DEPARTMENT OF THE AIR FORCE

SUBJECT: Building 1080 and Hansel Phelps Spill Sites

Sample and Analysis for Soil Remediation Wastes from Building 1080 and Hensel Phelps Construction Site

Bold/shading represents changes. This is change 2 dated 24 Jan 94.

Spill Site F-117A Maintenance Docks/Hanger Project

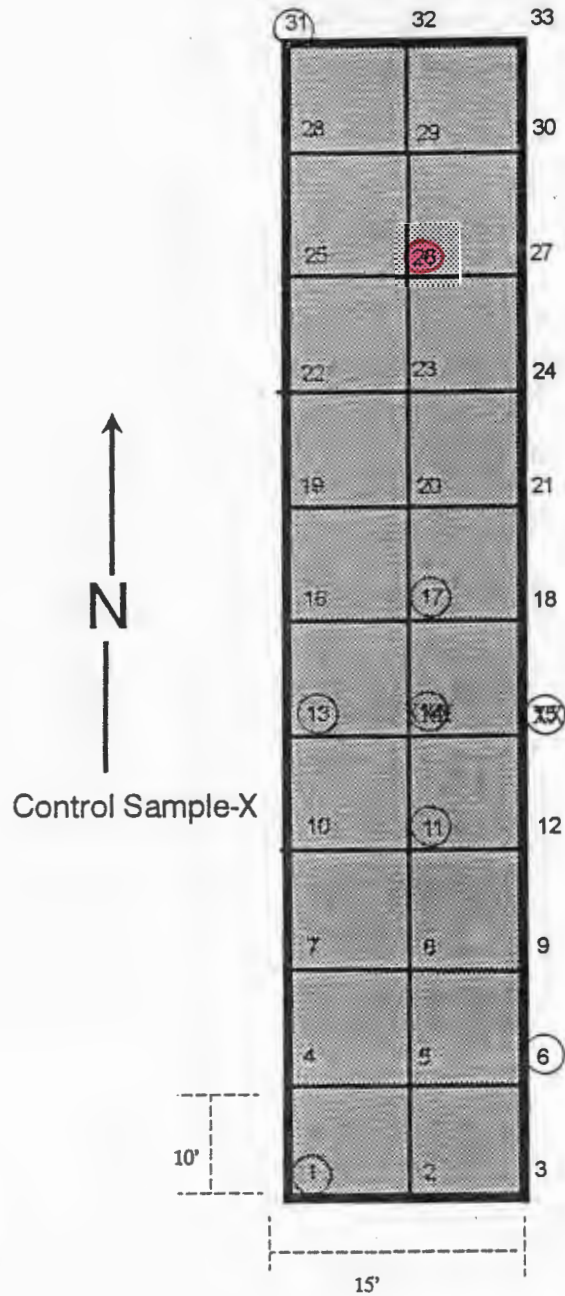
Note: Sample number 14 was moved to Sample number 26. Control sample number 15 is eliminated.
